Re: Public Version of the Comments on Vectren's 2016 Integrated Resource Plan

Report on Vectren 2016 IRP

Submitted to the IURC on April 17, 2017

Figure 21. Vectren 2016 IRP, Figure 7.19—Portfolio Standard Deviation Risk (vertical axis) vs. Expected Cost (horizontal axis) Tradeoff

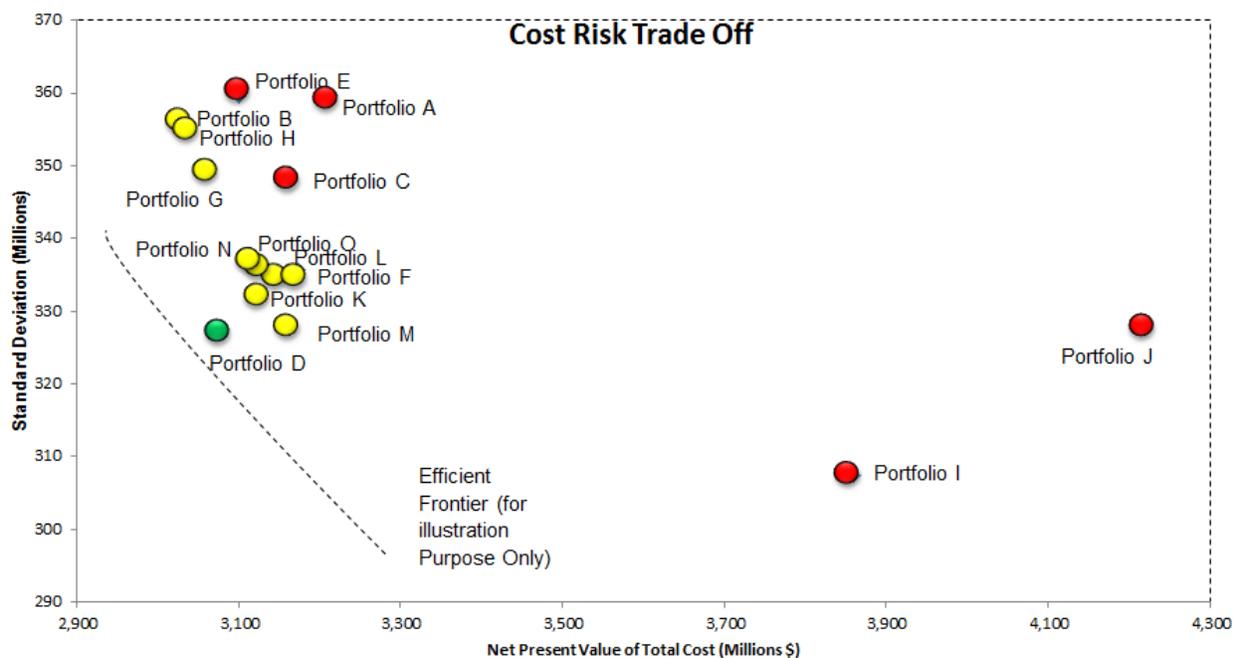
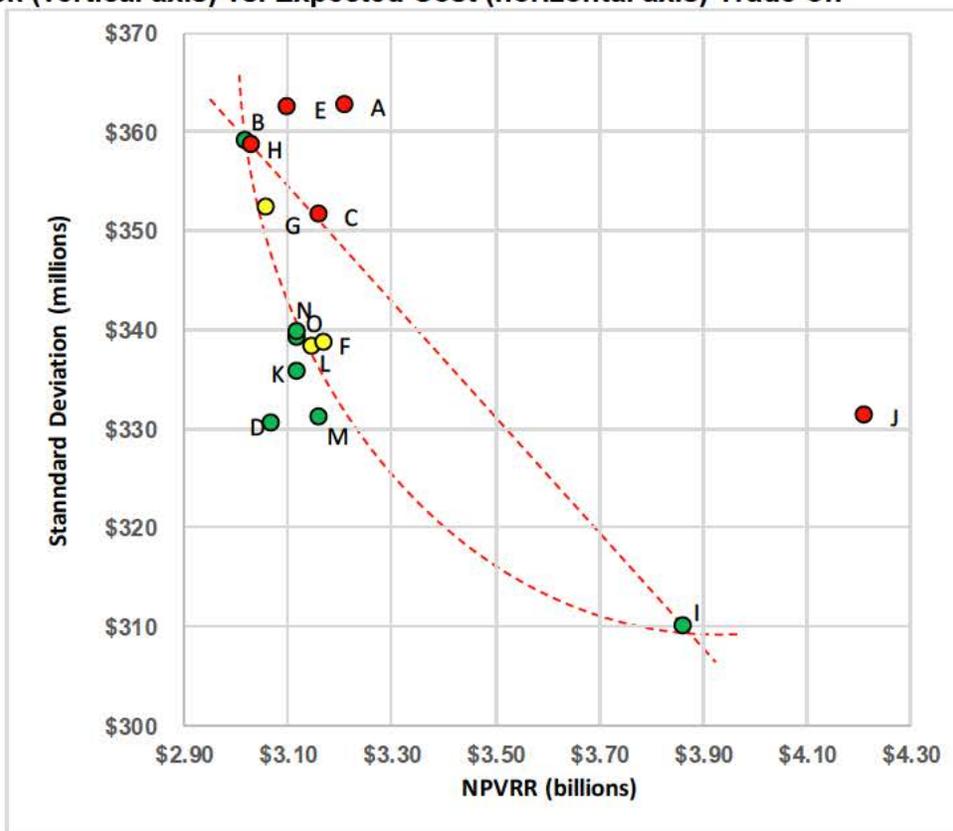
Furthermore, Vectren’s method of assigning scores to its Cost-Risk Trade-Off metric is entirely arbitrary. On page 229 of the IRP, a scatterplot of portfolio standard deviations versus portfolio NPVRR is presented. Vectren’s qualitative assignment of scores in this metric appears to be made on the basis of visual inspection of this graph and a sketched “Efficient Frontier (for illustration Purpose Only)” curve (see Figure 21).

Vectren’s illustrative, so-called “Efficient Frontier” (shown in Figure 6 above) is given without explanation or justification and appears to lead to a scoring system that is to the disadvantage of the two stakeholder portfolios, I and J. In order to illustrate the problems with Vectren’s method of assigning scores to a metric, Figure 7, below, reproduces Vectren’s data in Figure 6, but with a different rule of thumb for determining which portfolios receive which scores. Our equally illustrative “efficient frontiers”, drawn in Figure 22, both pass through the portfolio with

the lowest cost (Portfolio B) and the portfolio with the lowest standard deviation (Portfolio I). We have adjusted Vectren’s Cost-Risk Trade-Off scores based on each portfolio’s position with respect to these two frontiers.

Figure 25. SNL historic sales and Vectren projected sales by sector, 2000 - 2036

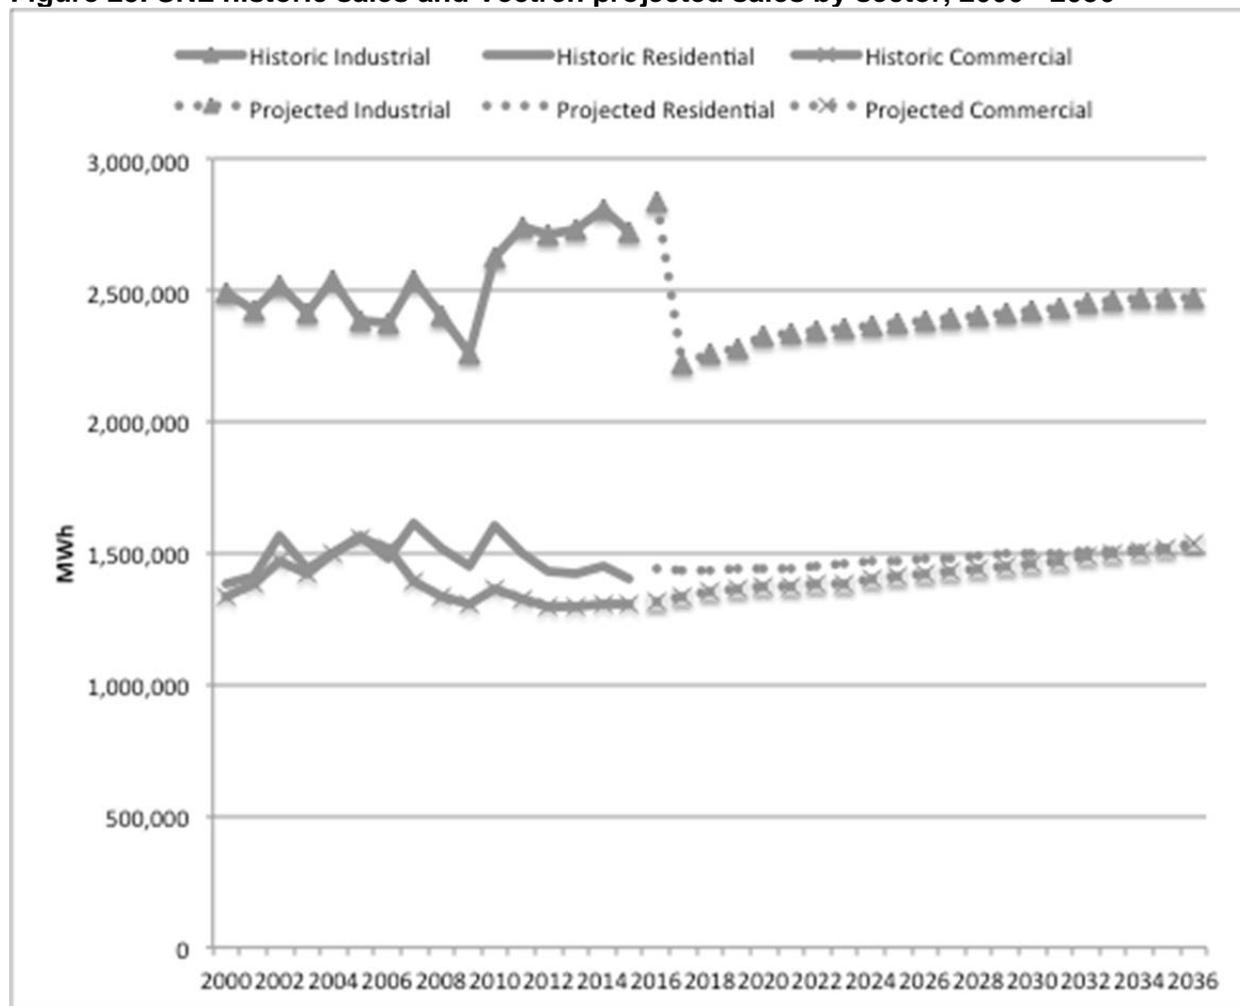
Given these very optimistic assumptions from Moody's and by Vectren, it should not be surprising that the commercial and industrial sales projections are driving the overall projected growth in sales (Figure 25).
